**Land 800 metres South of Park House Farm, Meriden Road,
Fillongley, North Warwickshire**

**Sam Oxley CMLI on behalf of North
Warwickshire Borough Council**
**Landscape and Visual Effects, and
Consideration of Green Belt**

Final report

APP/R3705/W/24/3349391 (PAP/2023/0071)

Figure 3.13 Extract of Viewpoint 7 visualisation, showing the extent visible in winter marked up

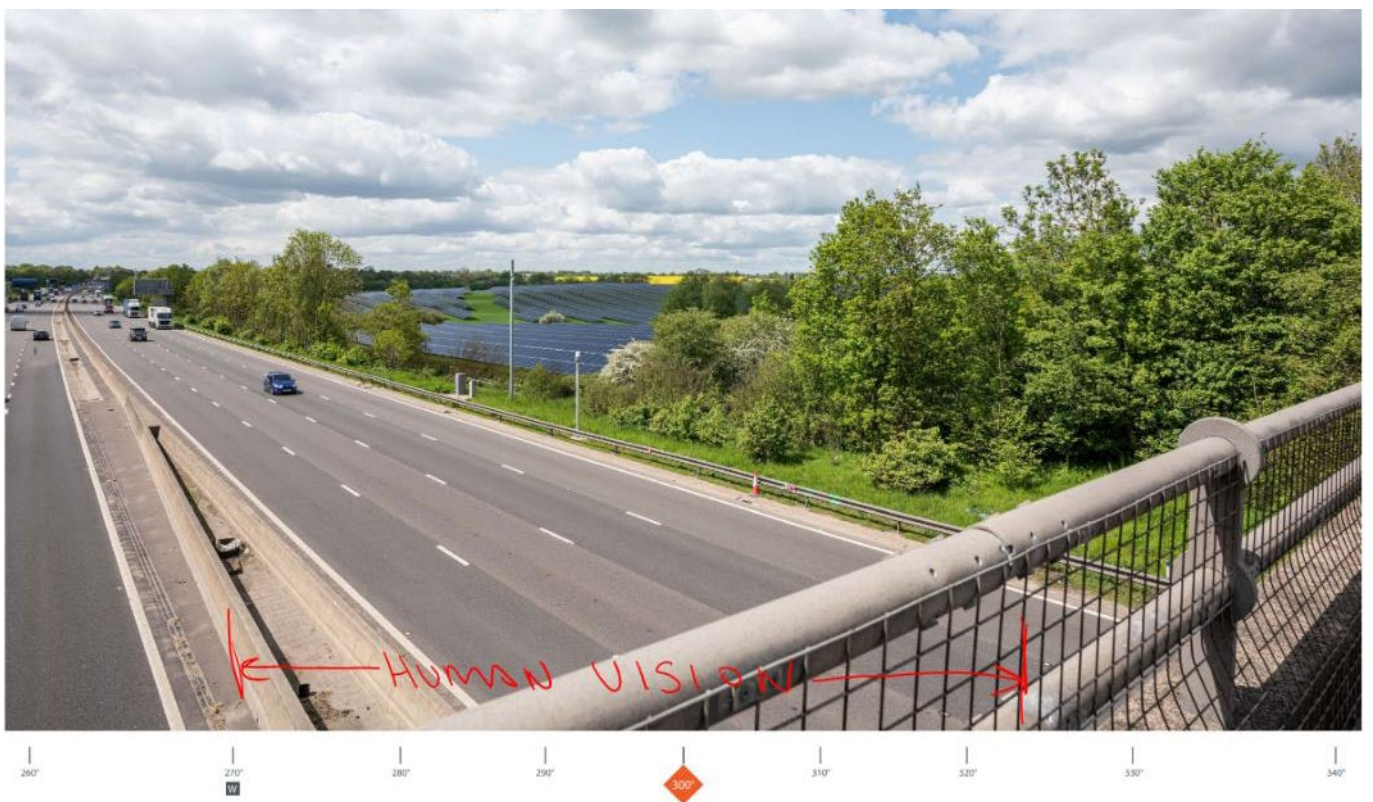
Figure 3.12 Winter view from VP7, showing the area to the right of the clump of trees is visible

Figure 3.14 Extract from Design Statement, Figure 5.4 Proposed perimeter fencing, page 11 CD1.11.

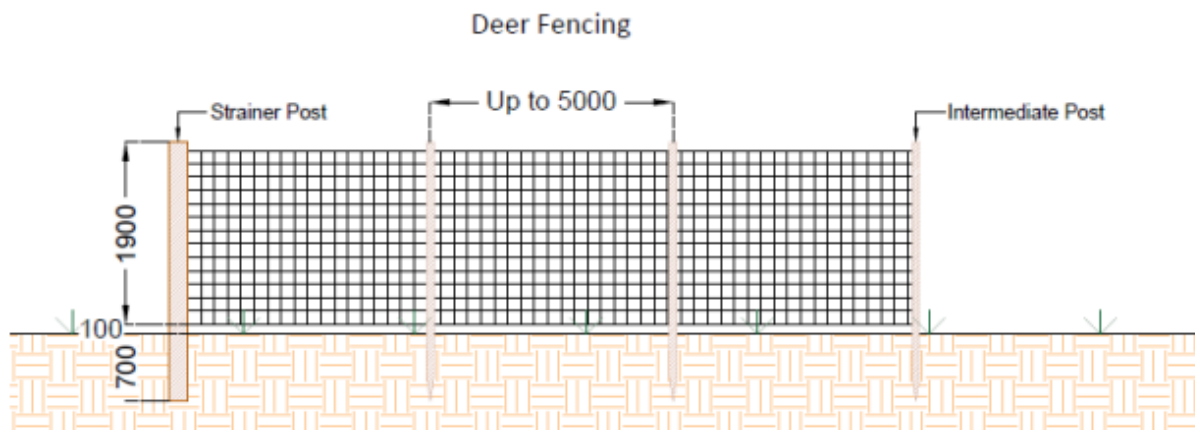
- 3.62 The applicant's LVA [CD1.22] does not appear to consider the effects of security fencing and gates. Some further information is given in the applicant's SoC [CD9.2].
- 3.63 2m perimeter fencing would be steel wire, which would enclose the site on all sides. Whilst labelled as deer fencing, its purpose is one of site security, and it will be used extensively. It will alter the character of the landscape and the visual amenity of those passing alongside it, especially via PRoW, making the landscape feel less open and rural.

Figure 3.15 Approximate Visual Envelope [Figure 6 of the LVA] aligned with bare earth ZTV below at a similar scale

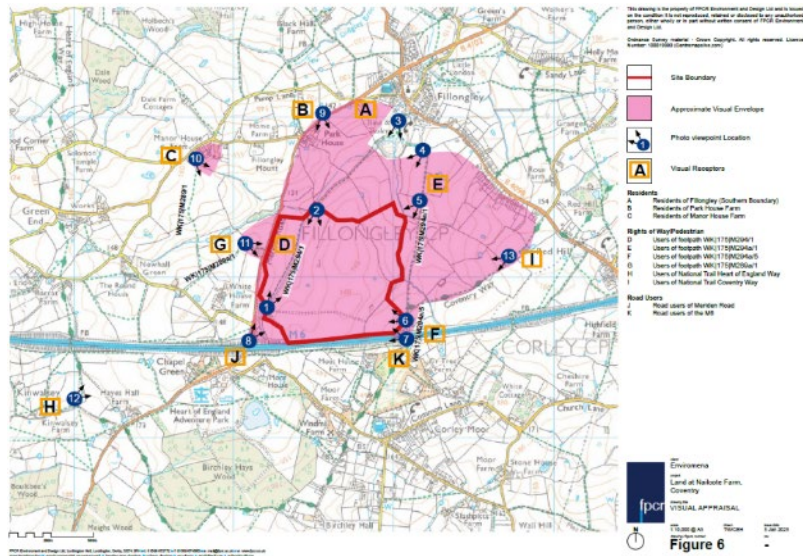
- 3.65** The applicant provided a hand drawn Approximate Visual Envelope (Figure 6 of the LVA) as part of the original LVA [CD1.22].
- 3.66** This provides an approximation of the extent of visibility but in places the approximation is incorrect. In particular it is wrong in that the visibility from the west is not captured. There are clear views from Green End Road and the area of Home Farm, Fillongley Mount, and further south from the area around White House Farm. There are longer distance views from the north for example around Tipper's Hill Farm. There are also views from the south despite the woodland along the M6. When standing on the site properties to the south of the M6 can be seen, which in turn means there will be views available from these properties – this is the area around Corely Moor, Kinwalsey, Hayes Hall Farm, Windmill Farm.

- 3.67** A new Bare Earth ZTV (Figure P24-1827-EN-09, [CD9.3] Appendix 9) was provided by the applicant in October 2024. As would be expected, this ZTV closely mirrors the topography (see topography on Figure 5 of the original LVA), and extends out to the enclosing ridgelines to the west, south east and north.

Figure 3.16 Bare Earth ZTV [Drawing P24-1827_EN_09 of the SoC]

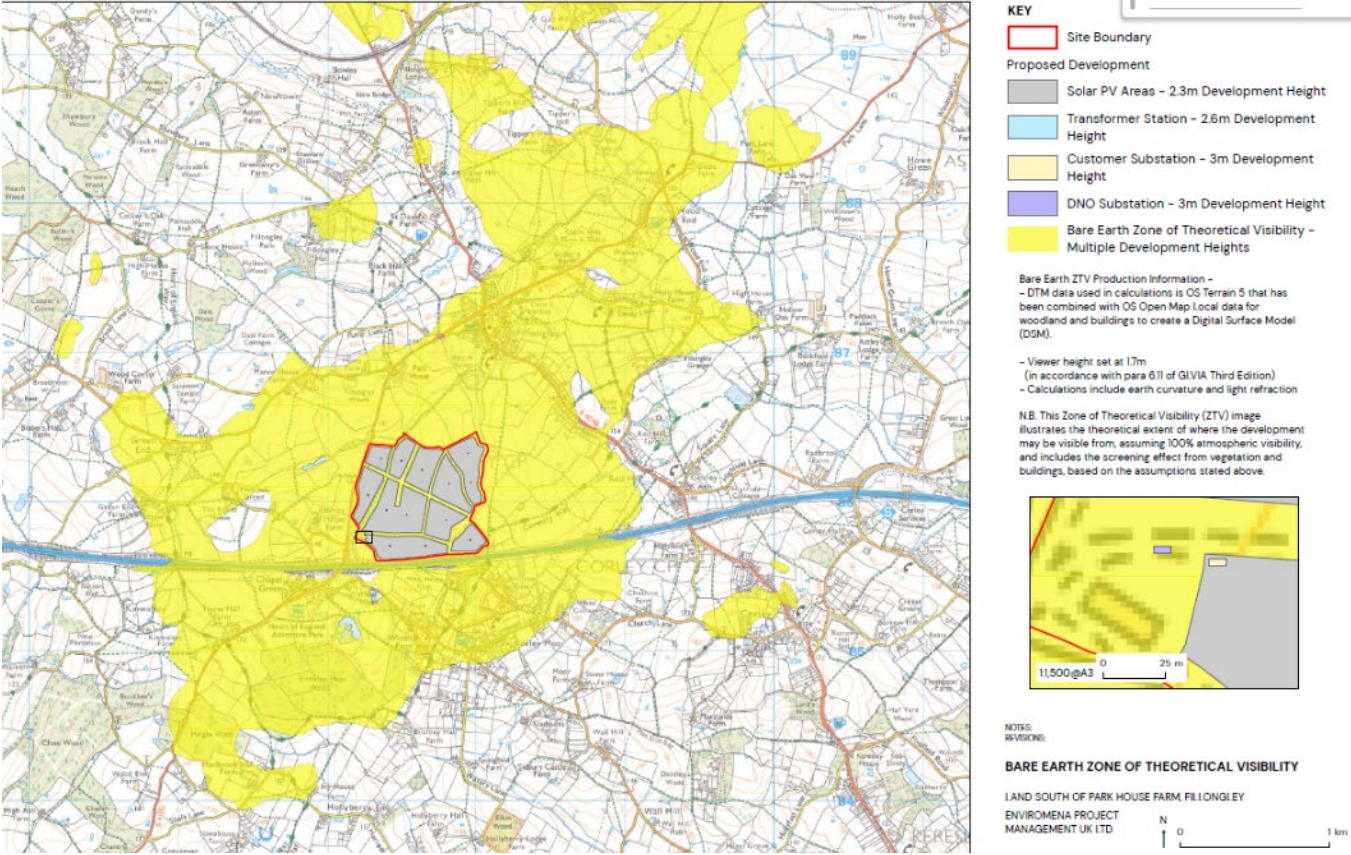
- 3.69** The new ZTV provides a more accurate representation of the extent of theoretical visibility. I can confirm through site visits that the wider area now shown will frequently have visibility of the proposed development, particularly in the years whilst mitigation planting is maturing. Areas where there is dense woodland (shaded green), and the built-up area of Fillongley would not enable visibility. In addition, hedgerows would locally filter views.
